NAVAL MEDICAL RESEARCH INST BETHESDA MD
A PRELIMINARY HUMAN ENGINEERING EVALUATION OF HYPERBARIC CONTRO--ETC(U)
MAR 77 W W BANKS, D M HEANEY, A J BACHRACH

A PRELIMINARY HUMAN ENGINEERING EVALUATION
OF HYPERBARIC CONTROL SYSTEMS

Research Subtask M0099-PN.03-3022

March 1977

Fig. 14. Example of poor task-loading decision.

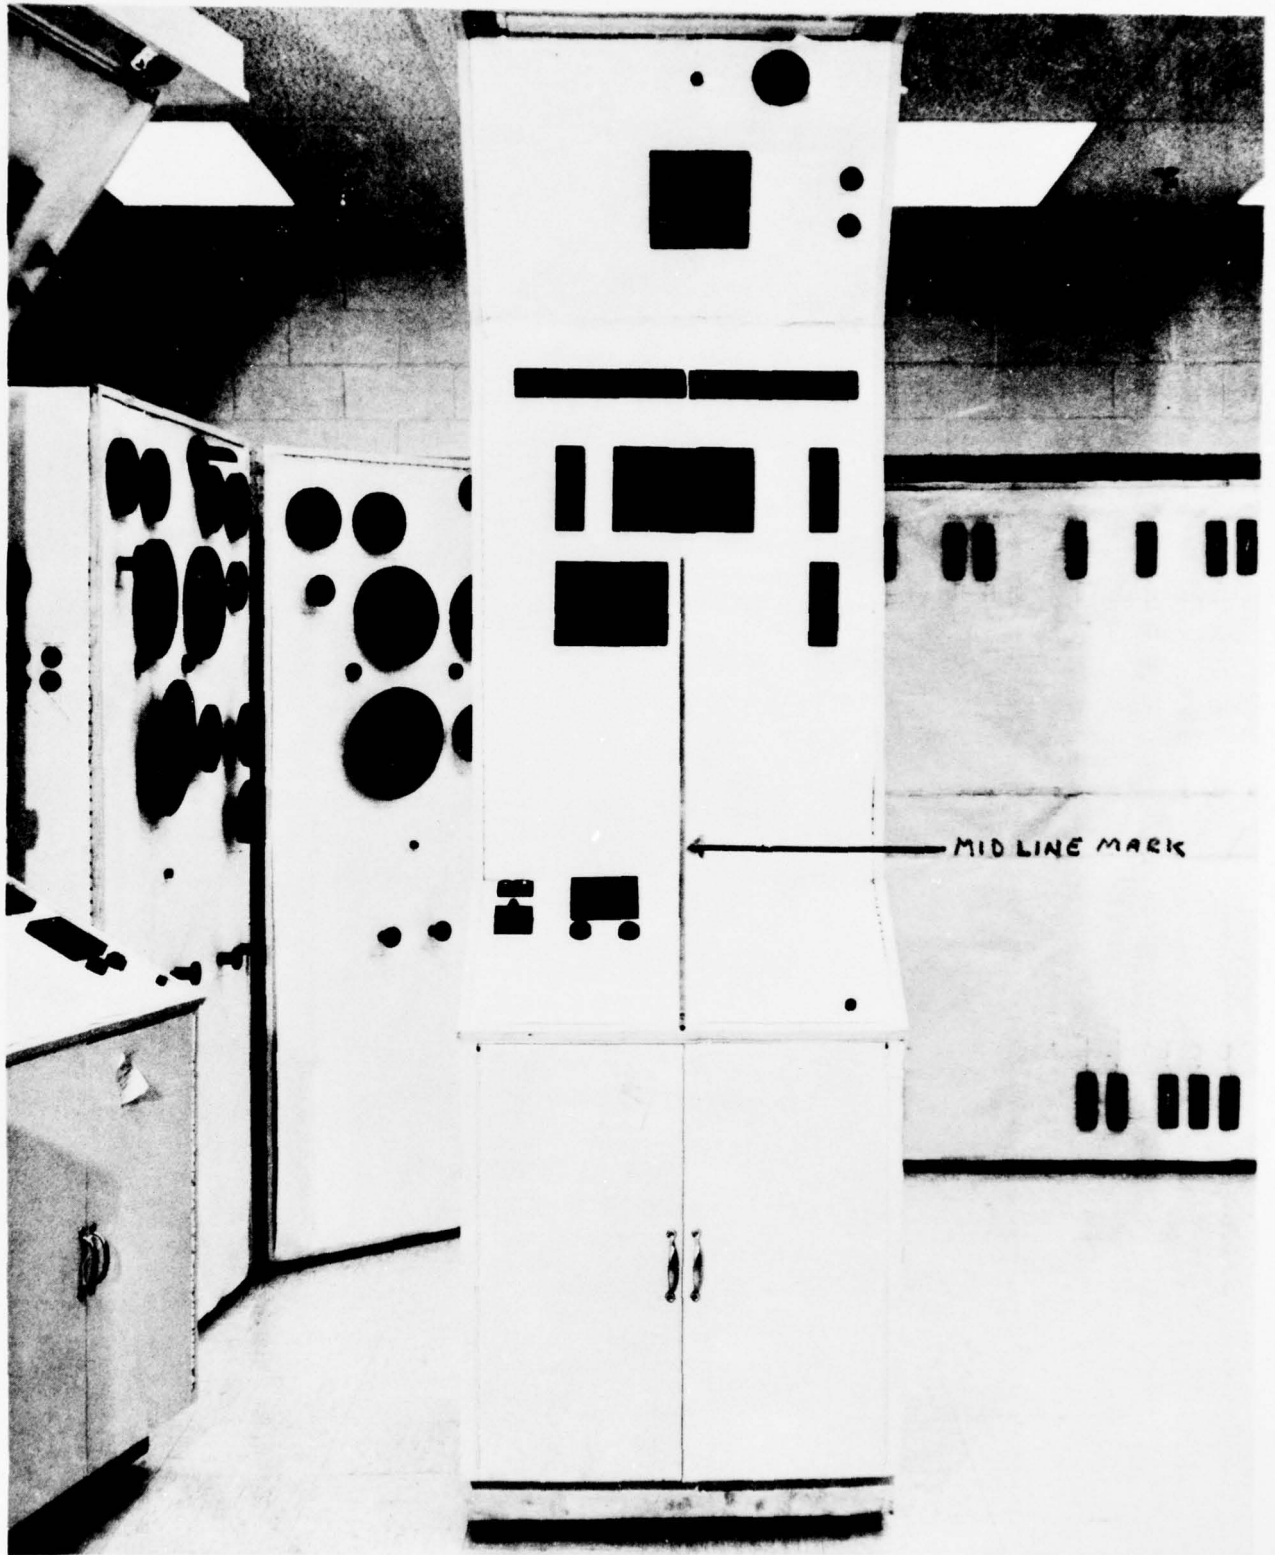
Figures 14 and 15 show a similar situation where all five functional controls are situated to the left of the panel midline mark. These panels present more of the work task to the left hand of a control-panel operator. It is therefore recommended that controls be convenient to the operator's right hand, which shares the larger portion of the control task. Control placement should also be dictated by the priority of task function, where high priority and frequently used components would be located in the upper-right quadrant or the most easily accessible area of a panel. Frequency-of-use studies will be conducted in the near future and the results will be published for use.

Fig. 16. The placement of the O_2 manifold in relationship to the O_2 meter is shown (panels #3007870 and #3007872).

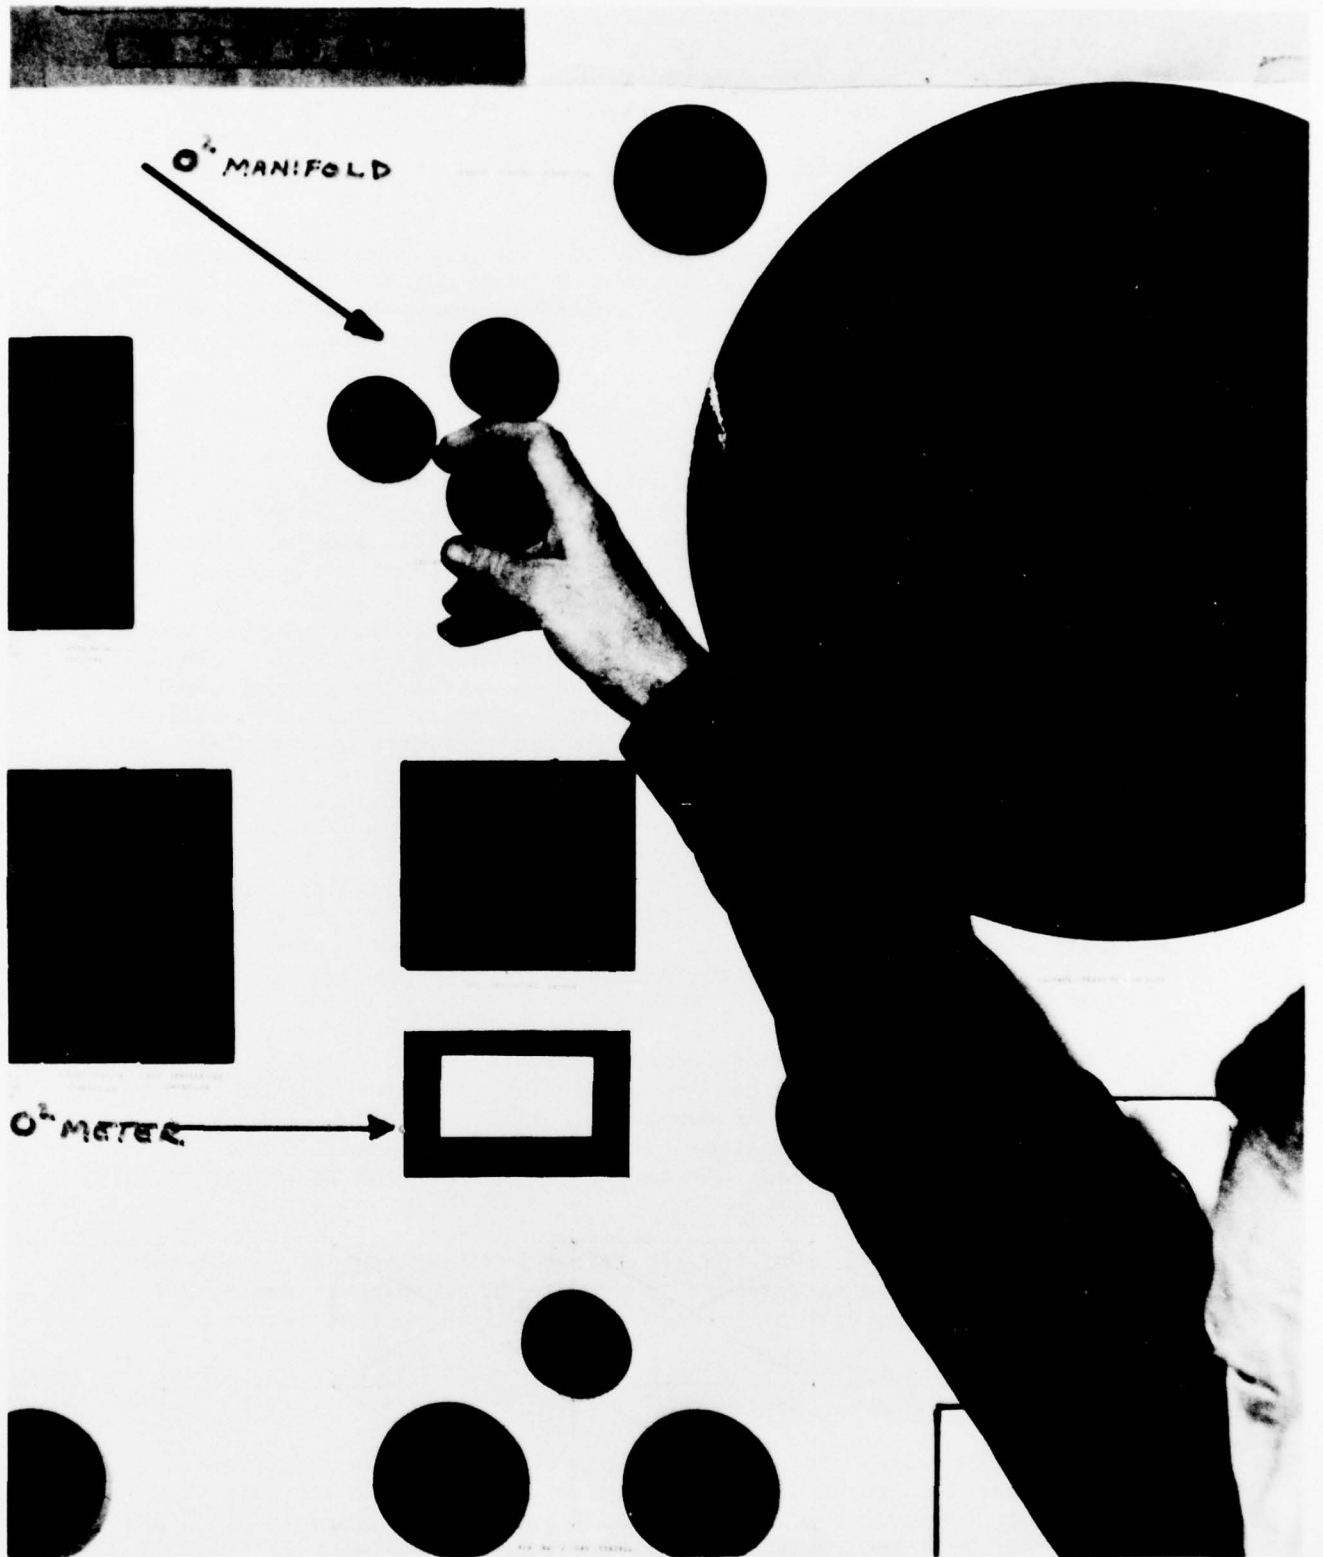
The oxygen manifold is part of the oxygen make-up system. It consists of one bypass and two isolation valves; it is used to add oxygen to the chamber in a predetermined concentration. This system (Fig. 16) is manually operated and provides visual information to the operator via the oxygen-level controller, which is a display meter. This meter gives the operator time-delayed feedback as to the percentage of oxygen in the hyperbaric chamber.

Six experienced Navy divers were asked to turn the valves of the oxygen manifold and report on the ease or difficulty of this operation as it relates to the clearance of their fingers/knuckles. Figure 16 provides an illustration of this operation. Five of these six diver subjects reported that the spacing between these valves (1) retarded their efforts, (2) caused unwanted contact with one or more other valves, and (3) required that they orient their wrist/arm in an unnatural position. In addition, two of these six divers (5 feet 6 inches and 5 feet 7 inches in height) reported that the oxygen manifold was placed too high on the panel relative to its associated importance. Although these reports were subjective, virtually all of these six divers were observed

to come in physical contact with valves they did not plan to operate while they were attempting to move any given component on the oxygen manifold. This observation would appear to validate a portion of the diver reports.

It should also be pointed out that the corresponding relationship between the oxygen manifold and the oxygen-level controller meter (bottom arrow on Fig. 16) is not optimized. A further discussion of this is found under the section of this paper labeled "Control-Display Relationships."

Fig. 18. MRCC panel #337870: The components of the environmental control system labeled A, B, and C are displayed. Note that they are not grouped together, but are separated by 23 inches. In addition, controls A and B appear to comprise part of the BIB gas meter controls.

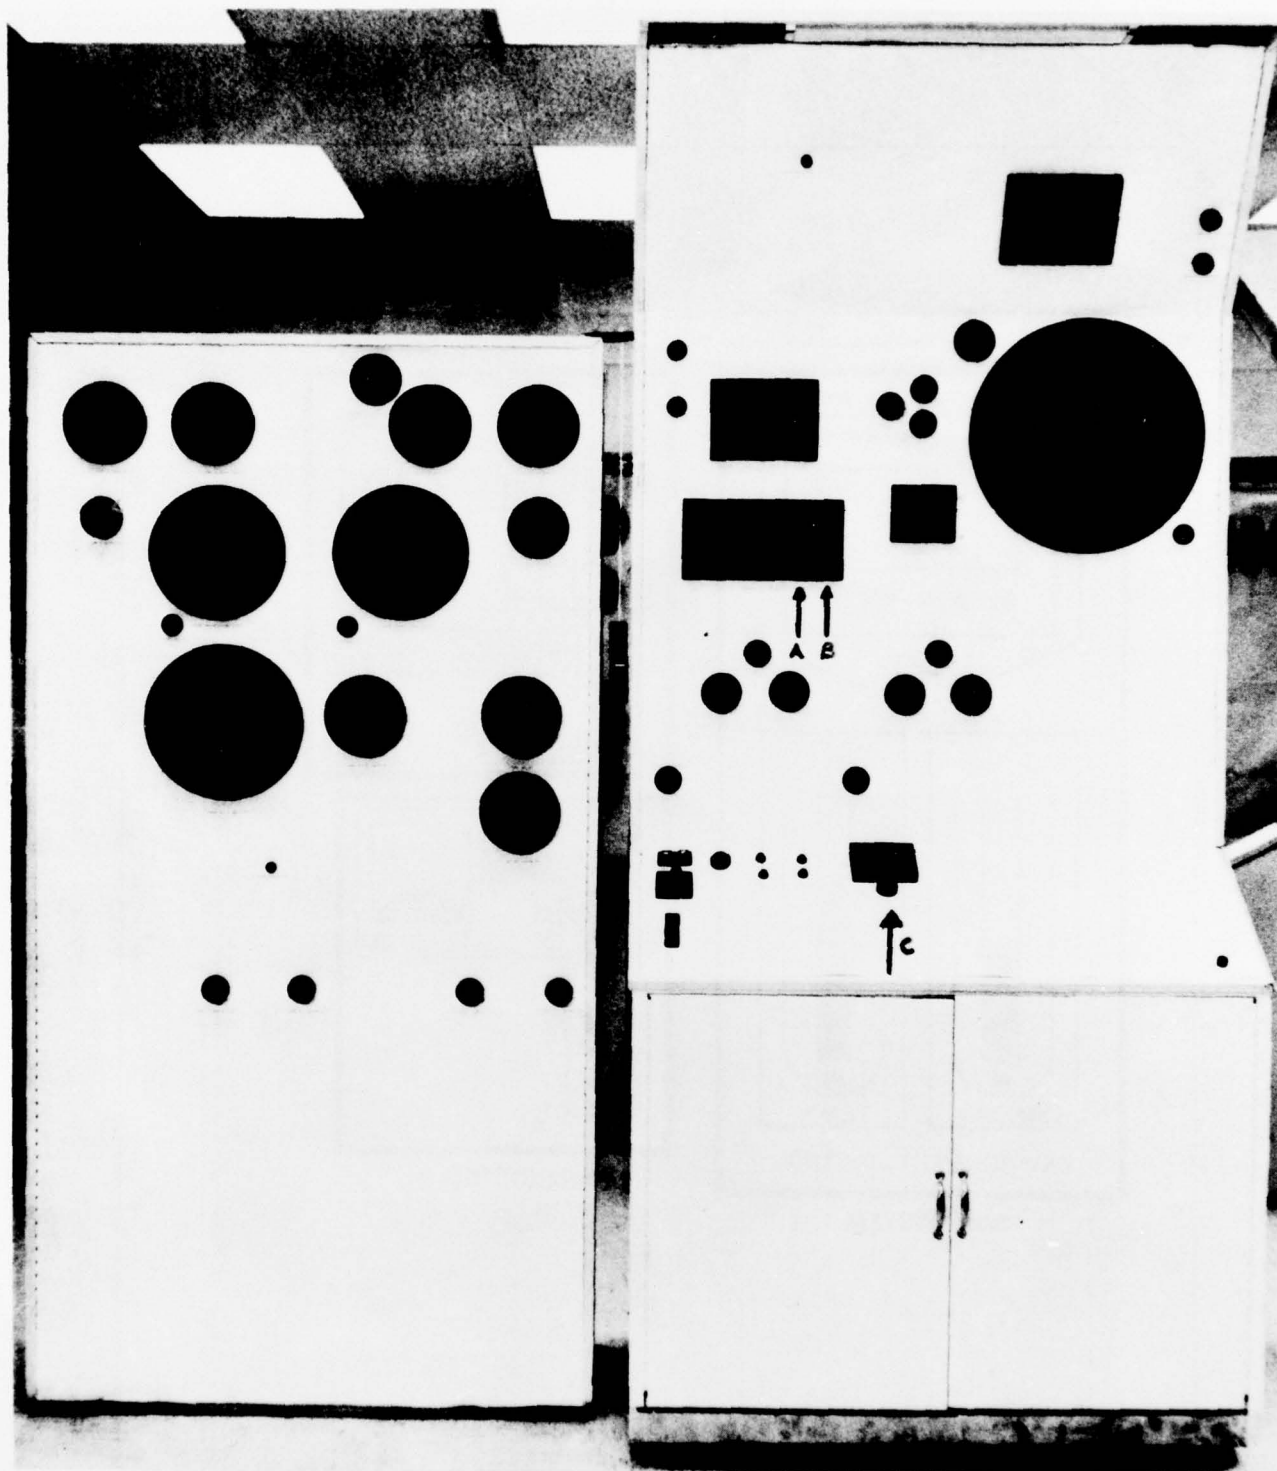
In comparison, however, Fig. 18 indicates three similar components of the MRCC panel, which are labeled A, B, and C. Component A is the humidity control/indicator; B is the temperature control/indicator, and C is the blower fan/speed control/indicator for the atmospheric-conditioning system (ACS).

Although these components form part of the internal weather system of the hyperbaric chamber, they are physically separated by over 2 feet. Components A and B give the appearance of being part of the BIB pressure and mixed-gas indicators (to the left of the arrows labeled B and A), but their function is totally unrelated. This situation is unsatisfactory for the reasons given above.

Fig. 20. A seated diver unable to reach selected control panel #5007875 is shown.

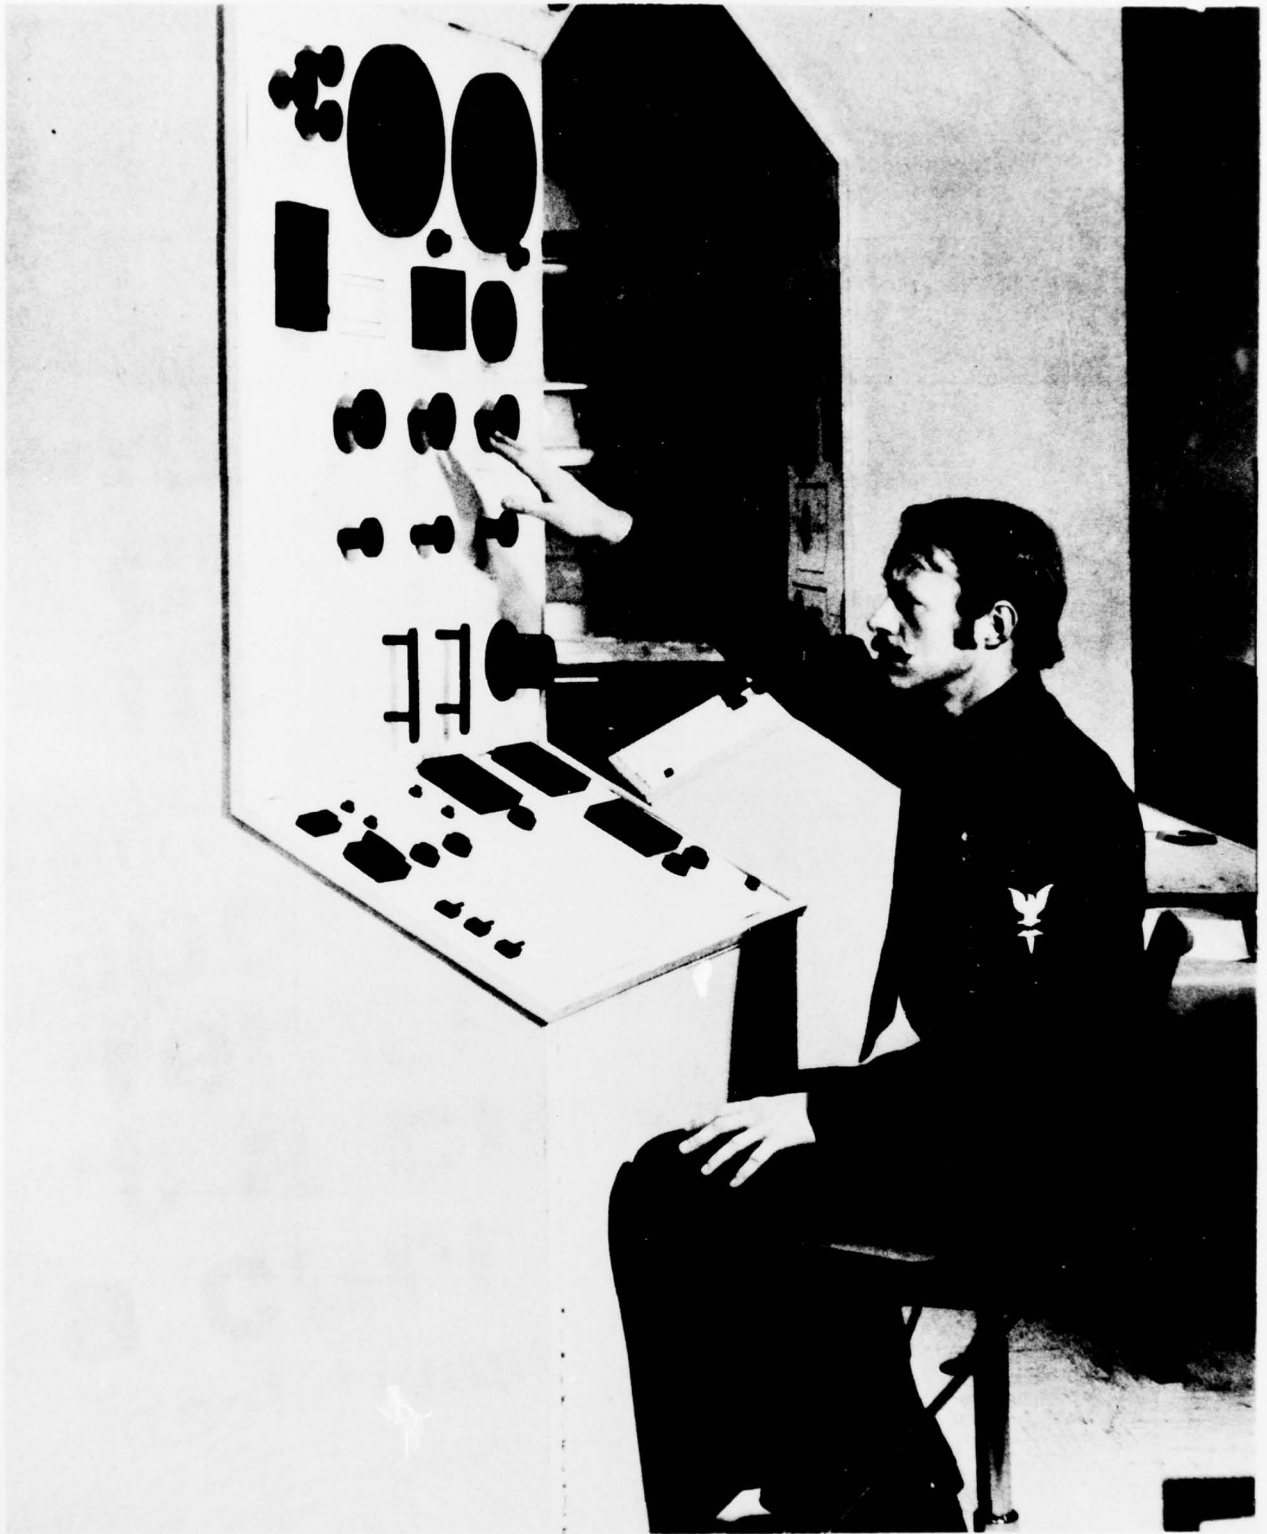
Specifications (MIL-STD-1472A, 1970), and which was acceptable to Navy divers in the 5th through 95th percentile-height (Beatty and Berghage, 1972). When this seating arrangement was used as a criterion model, none of the existing control panel mock-ups under evaluation was satisfactory. For example, it was empirically determined that the 75th percentile Navy diver had access to less than an average of 64% of the controls from a seated position when Reference A (see Fig. 13) was extended to a full 22 inches. Even when the mock-ups were examined with the diver in a standing position, they were poorly instrumented from the standpoint of accessibility.

Table 1 displays the percentage of controls reached by both standing and seated control operators. Note that the range of accessibility from the standing position was 70% to 80%. The seated operator has much more difficulty: the percentage range averaged from 48% to 74% for the 5th, 25th, 50th, 75th, and 95th percentile-height operators. Figure 20 shows a seated diver at one control panel. He is representative of the 65th percentile Navy diver in height. When asked to reach for each control without stretching, only 50% of the controls were in his reach or in a good field of view. Even when the seat was raised from 18 inches to 29 inches (see Fig. 21) and the diver was asked to stretch his reach as far as possible, 6 control functions were still out of his reach.

It is suggested that the control panels be modified to accommodate the seated operator. As a minimum requirement, the controls should be repositioned so that Navy divers in the 25th to 75th percentile-height range have unobstructed access to at least 80% of all control functions from the seated position. One solution would be to mount controls on a horizontal wrap-around console. In this manner the access area of the panel control surface would be increased by a greater factor compared to present designs (see Fig. 22).

Fig. 23. The right console mock-up was constructed from contractors' plans; the left is a modification based on preliminary human factors studies.

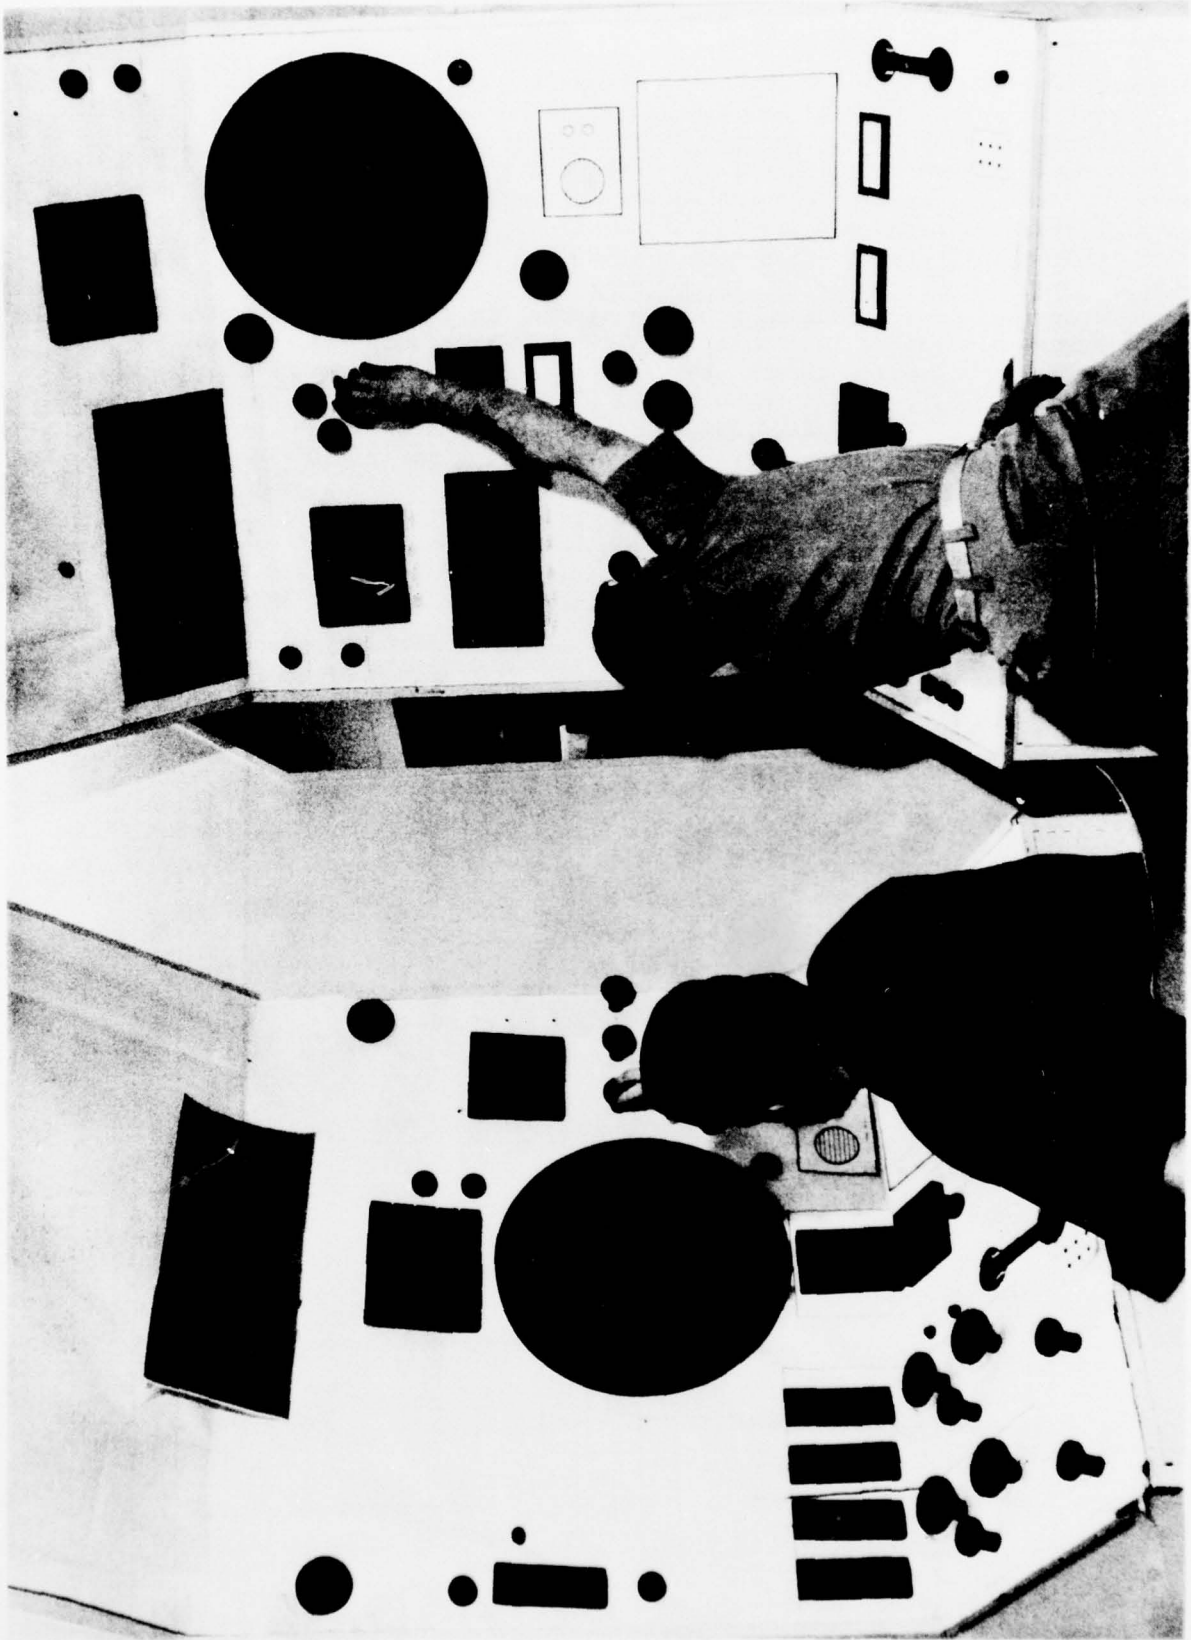
If attention is not focused on these issues, it is likely that the control system will offer less than its intended efficiency and purpose. That purpose is to provide smooth, reliable, and safe operation of the equipment and to insure the success of the mission. The control panel on the left of Fig. 23 is one of many alternate designs that are currently being compared with the contractor-supplied panel design (right side of Fig. 23). Notice the degree of body and hand movement required of the seated operator on the right for activation of the oxygen manifold. The operator on the left, however, has no difficulty in reaching 96% of the manual controls on his panel. Comparisons such as these will lead eventually to increased efficiency in operation and to over-all safety.
